Re Garvies Point Waterfront Mixed-Use Development
Second Amended PUD Master Development Plan and
Phase IIB D-E-F Site Plan
March 2021 Submittals

This letter has been prepared to address the review memo dated April 27, 2021 from Mr. Robert G. Nelson, Jr., P.E., of Nelson + Pope (N+P No: 15122). Please note that the order of our responses follows the order of the original comments, and we have included the original comment followed by our response in ***bold italics***.

Garvies Point
Amended PUD and Block E/F

Garveys Point - Block A Parking Overlay
 NTS

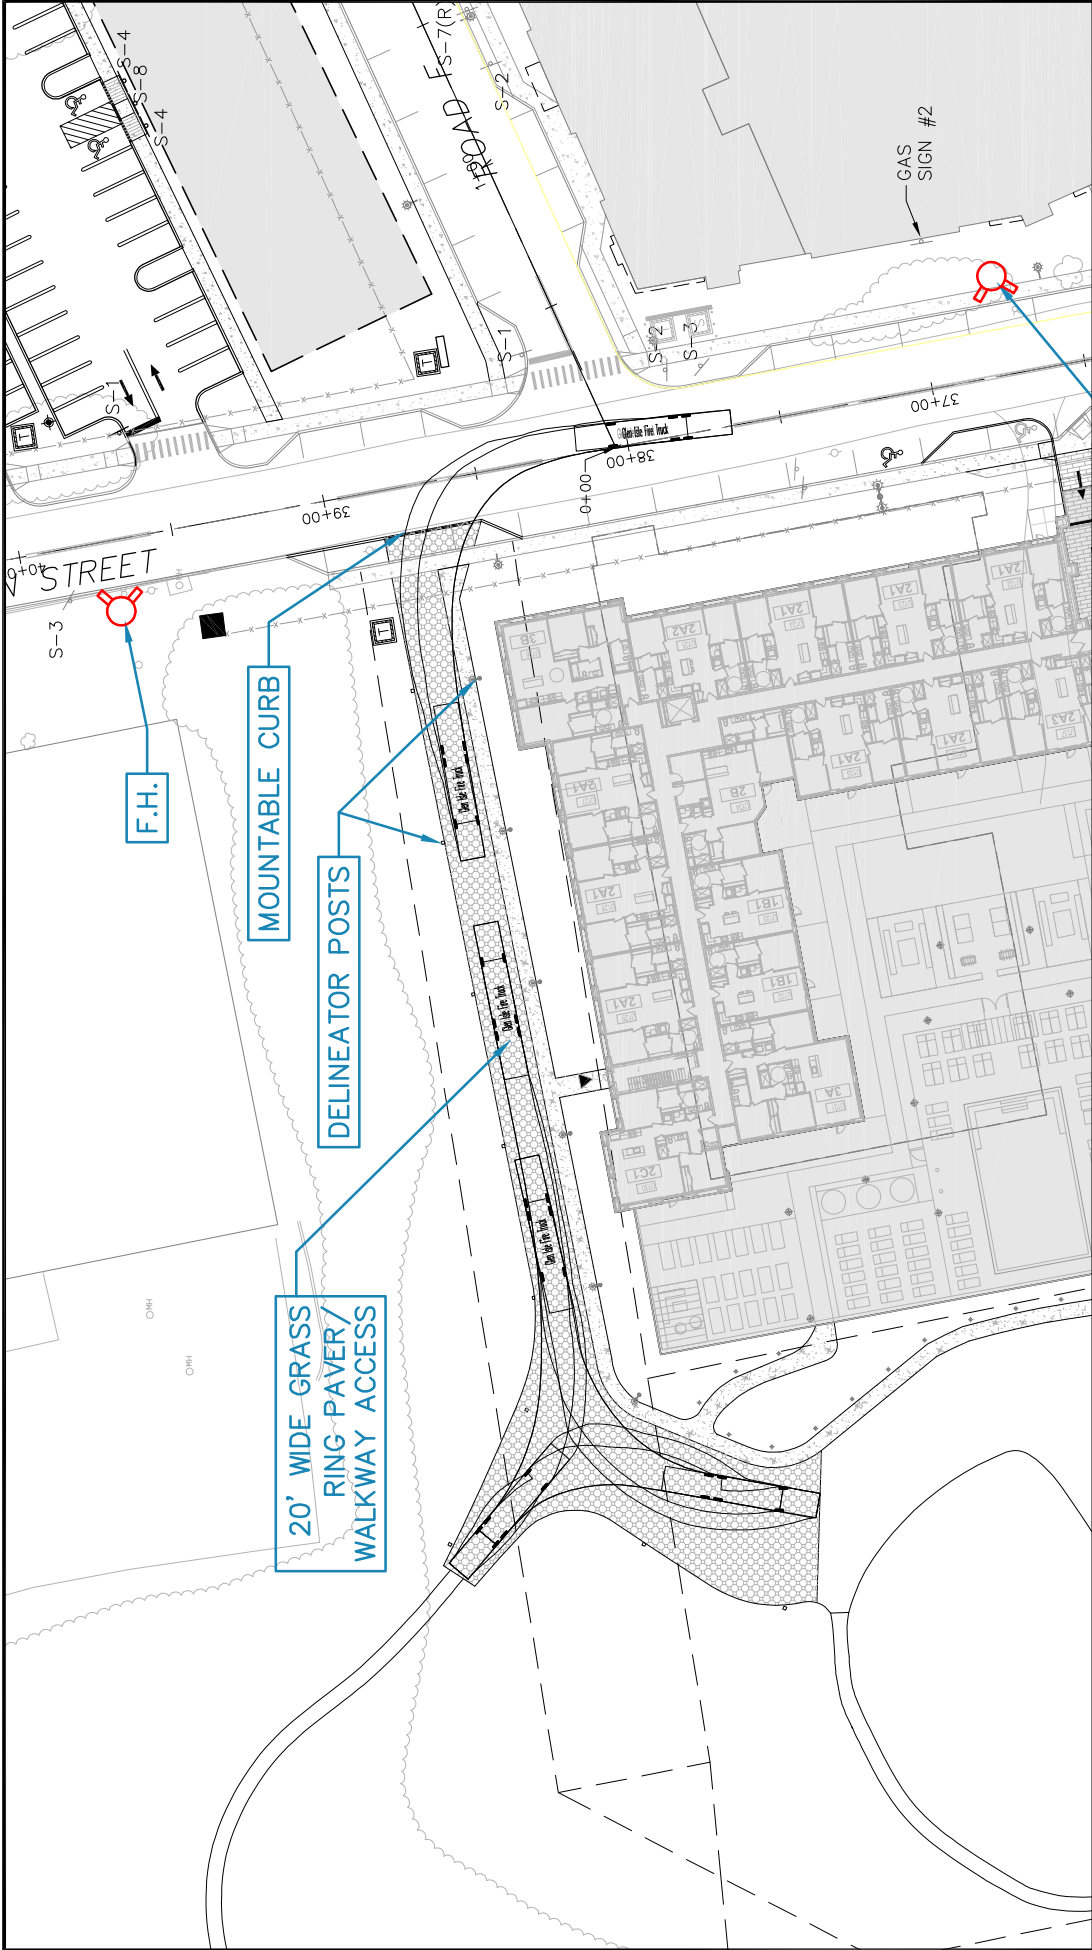
- The parking analysis references the reconfigured stalls as “angled” but in Attachment A the stalls are shown as perpendicular to the sidewalk. The configuration of the stalls need to be clarified.

- The stall reconfiguration in relation to the Garvies Point ROW and travel lanes is necessary to determine if the stalls encroach into the travel lanes or over the ROW line. The stalls should not reduce the State approved travel lane width. If stalls encroach over the ROW line in the PUD boundary, a ROW widening may be required.

- The on-street parking configuration needs to be depicted consistency on all the submitted documents.

RESPONSE: The proposed new on-street parking layout will be perpendicular to the sidewalk as shown on Attachment A.

RESPONSE: We have confirmed that the proposed new on-street parking layout will not encroach into the travel lanes as originally designed, nor encroach over the ROW. The proposed sidewalk will be located within the Block A site. Please see Attachment A.

SHEET TITLE
 FIRE TRUCK
 MOVEMENT PLAN

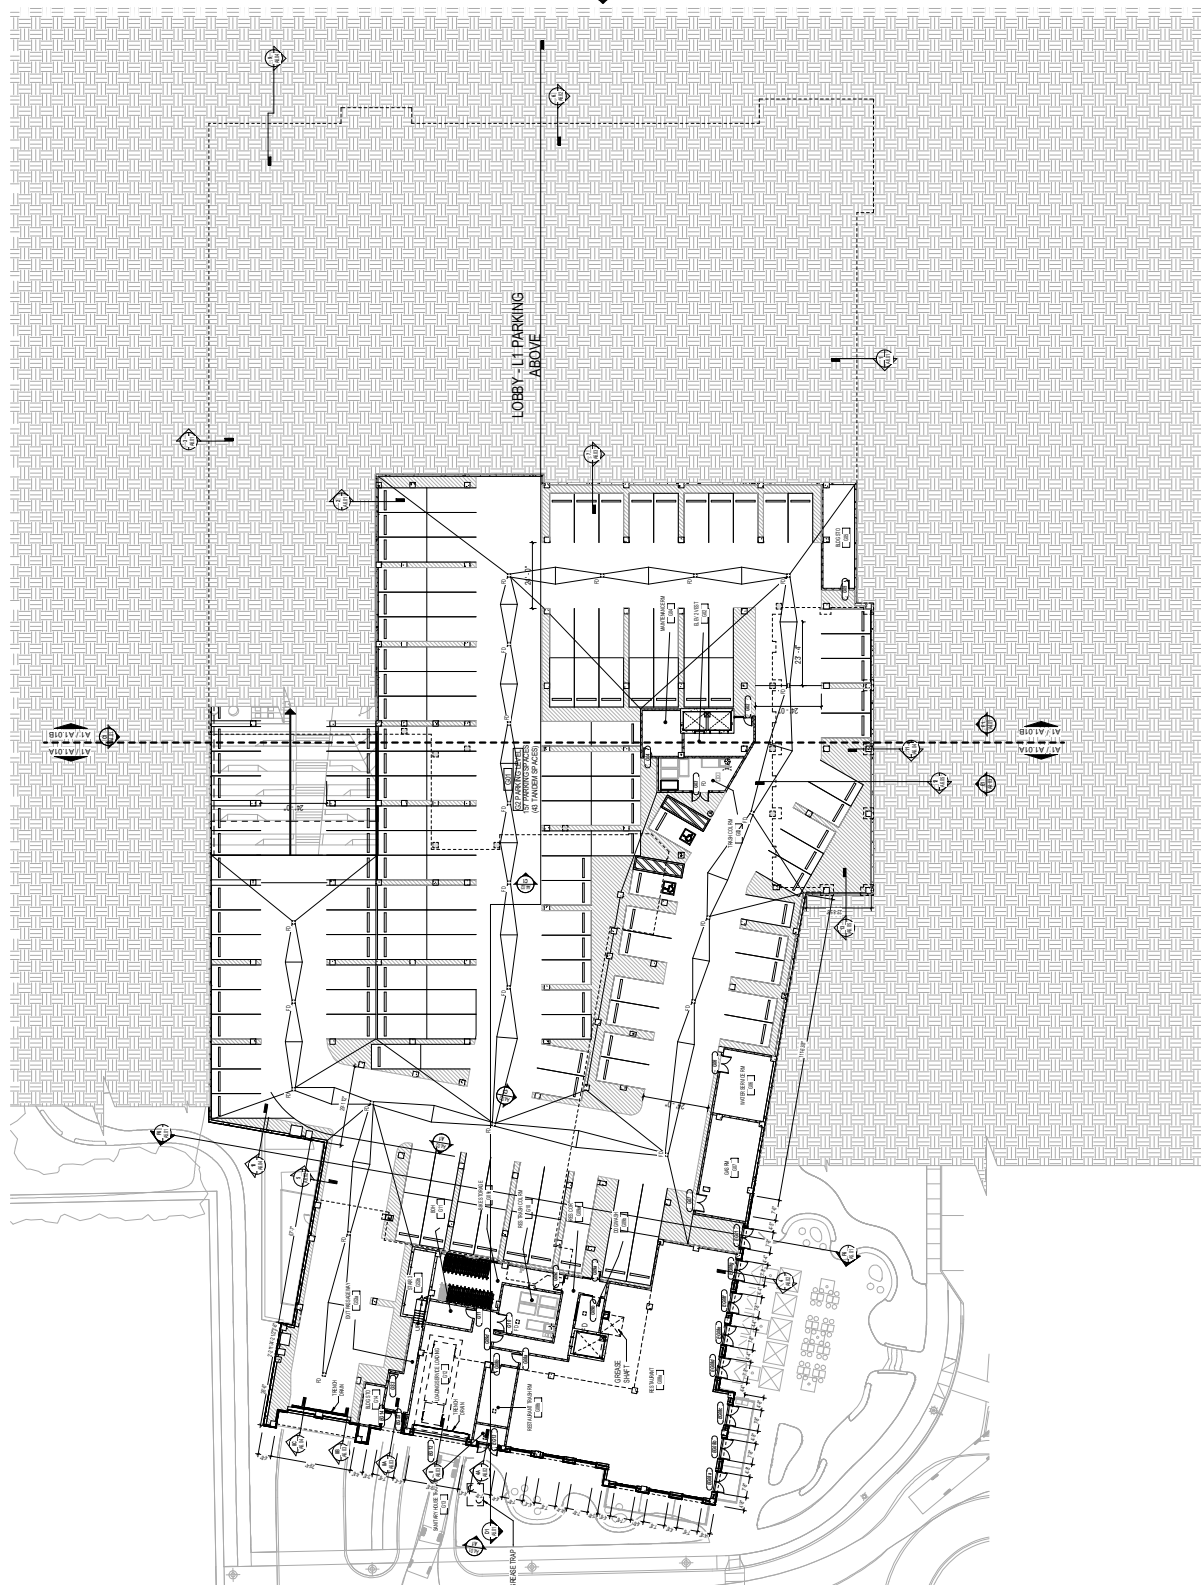
A review of the revised plans indicates there may be a "hammerhead" proposed for the emergency vehicle access route. A hammerhead is one of the techniques available to provide for an emergency vehicle, i.e. fire apparatus, the ability to turn around when the

emergency access route is longer than 150-ft from the nearest roadway. The hammerhead and emergency access road should be more clearly defined and include dimensions, route delineations, signing and detailing to show compliance with the NYS Fire Code.

RESPONSE: The plans will be revised to clearly depict the "hammerhead" proposed for the emergency vehicle access route. The associated dimensions, route delineations, signing and detailing will also be provided. See attached exhibit showing the configuration as well as the fire truck turning maneuvers.

G1 - Garage Plan

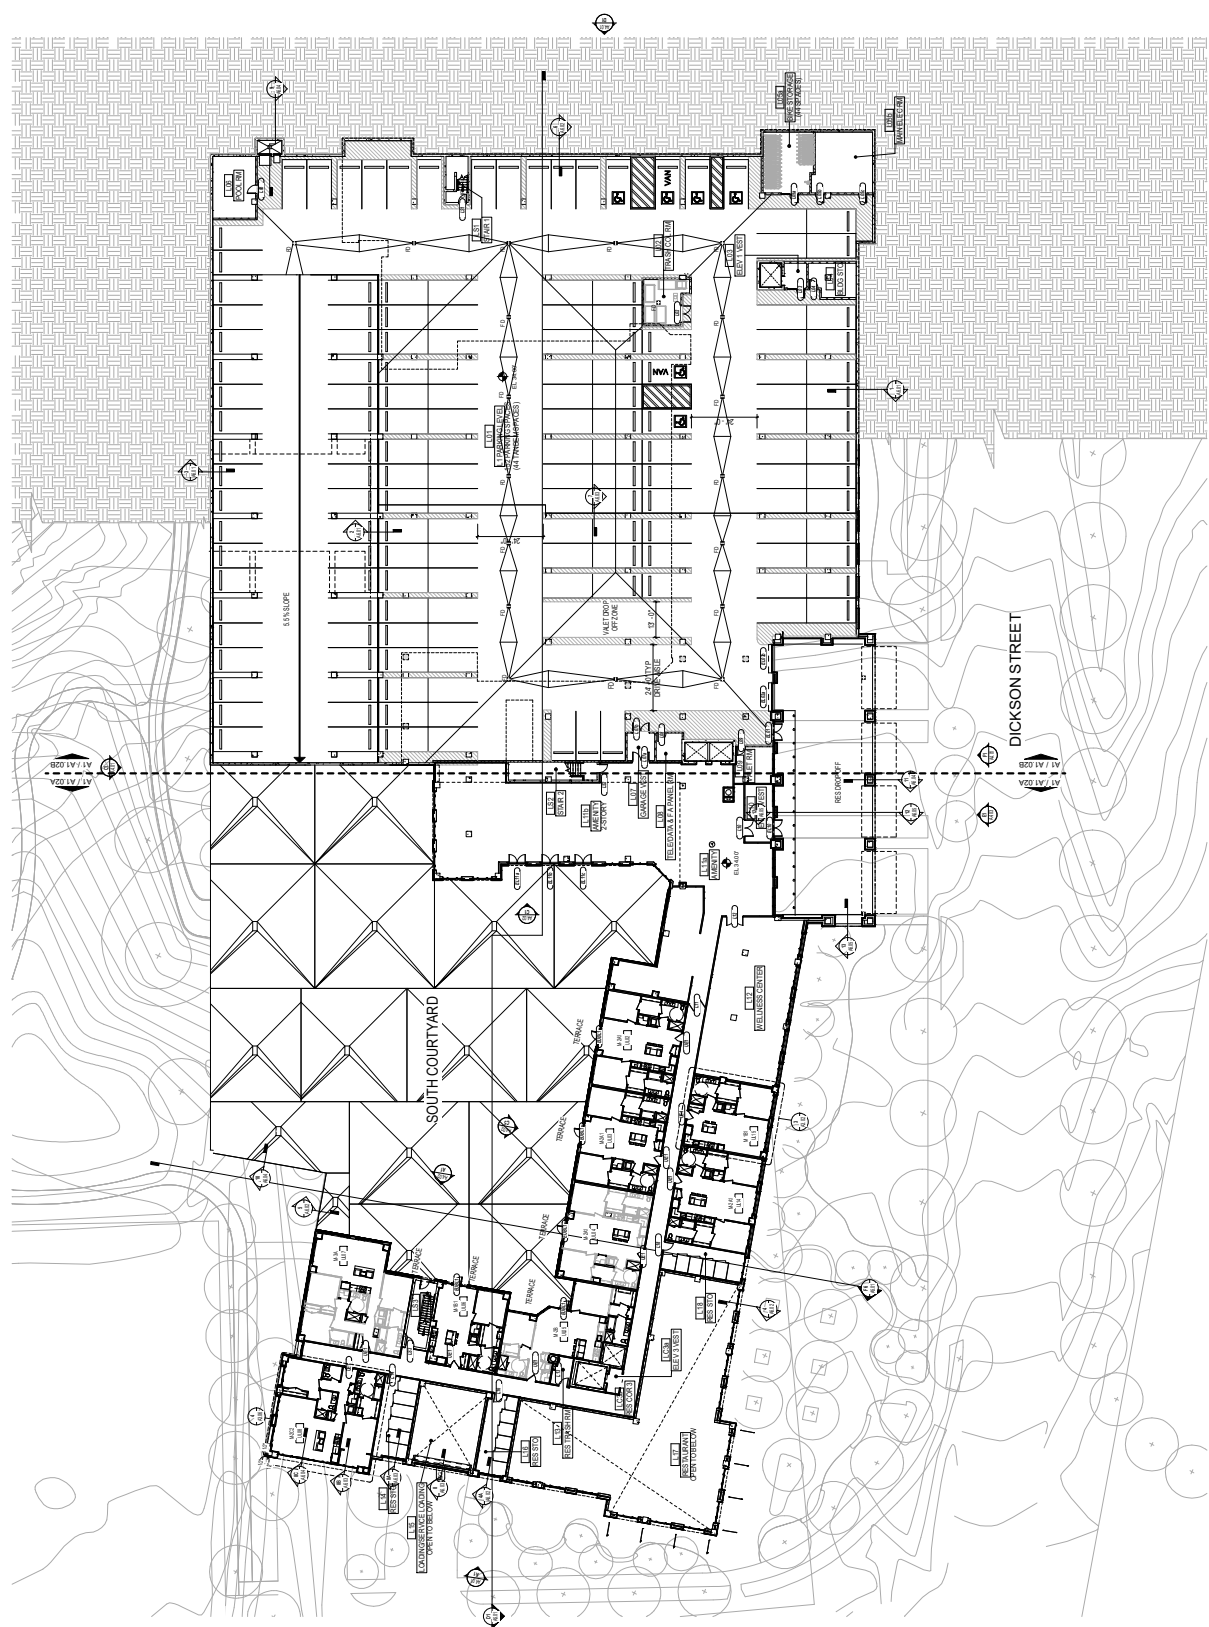
- e. Interior parking plan for the Blk. E/F should be provided to confirm the number of stall provided in the garage.

RESPONSE: The interior parking plan for Blk. E/F was included in the Architectural Set submitted in December; those pages are appended for reference.

Garvies Point Block D – Modified Parking

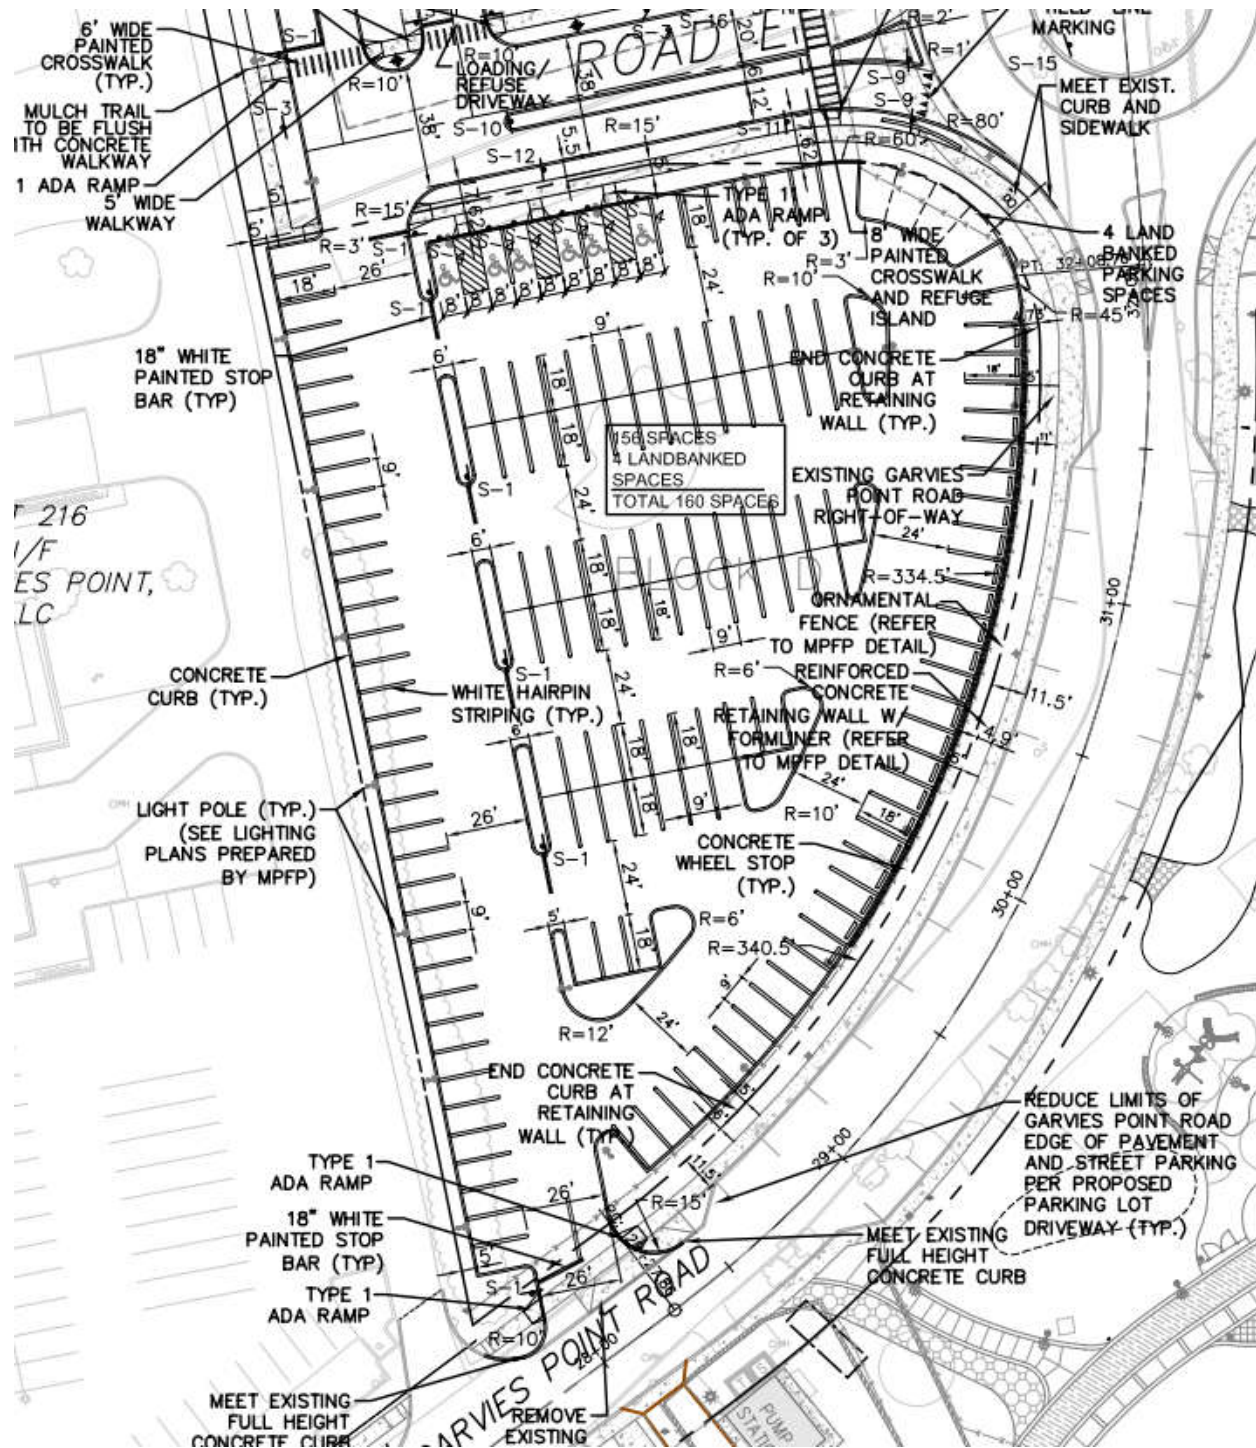
- d. Blk. D parking lot has been designed to maximize the number of parking stalls provided. This results in limited internal planting islands and landscaping along the Garvies Point Road and round-a-bout. As a further constraint to landscaping, to limit the disruption of the underlying soils, in compliance with the site's excavation and soil management plan, the site will require a retaining wall within the Garvies Point Road ROW. The following clarifications are required:

- Has the City DPW been consulted and agreed to the placement of a retaining wall within the Garvies Point Road and round-a-bout ROW?
- Additional dimensioning is required to determine if there is sufficient distance between the Garvies Point Road sidewalk and the retaining wall to allow the planting of street trees or other vegetation.

RESPONSE: In accordance with direction from the City of Glen Cove, the proposed retaining wall associated with the proposed parking area on Block D has been shifted so that it is no longer located in the right-of-way. This equates to a 5-space reduction in number of parking spaces provided within this lot: was 165 spaces total before the wall shift and 160 spaces total (156 + 4 landbanked) after the wall shift. In response to the discussion held with SA and the City on 05/07/21, four (4) parking spaces are proposed to be replaced with a sign and plantings at the NE corner of Block D (landbanked spaces). Refer to the MPFP memoranda. Refer to Attachment D.

Additional dimensions will be added to sidewalk and retaining wall.
